5DX - 72

S E R V I C E   N O T E

Agilent 5DX Systems
Series 3 Service/Reliability Enhancement

Serial Numbers: USXXXX100 - USXXXX654

Figure 1: Identification of the Z-linear rail Screws

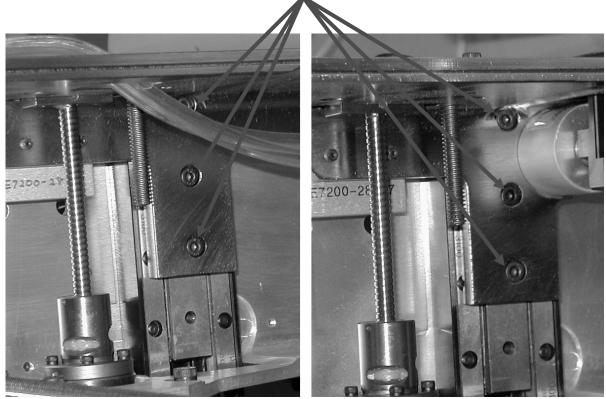
Situation:
The screws used to mount the Fixed Rail and Adjustable Rail to the Z-linear rails can become loose, which can cause the rails to contact the screw head. This causes the stage to be limited in its z-motion causing alignment and surface mapping errors. Often this appears as an intermittent problem.

Solution/Action:
Remove the screws one at a time that hold the adjustable and fixed rail to the Z-linear rails and add the new screws (0515-2801) and lock washers (2190-0073). These should be set to 45 inch pounds. If you do not have a torque wrench, tighten these screws very tight. There are twelve screws and twelve lock washers, six sets on the fixed rail and six sets on the adjustable rail. See Figure 1 for identification of the affected screws on the Z-linear rails.

After the screws are replaced, run **lsmztest** from the command prompt to verify that the rails are properly aligned.

NOTE: Do not add Loctite to the screws. Loctite can cause the linear rails to bind.
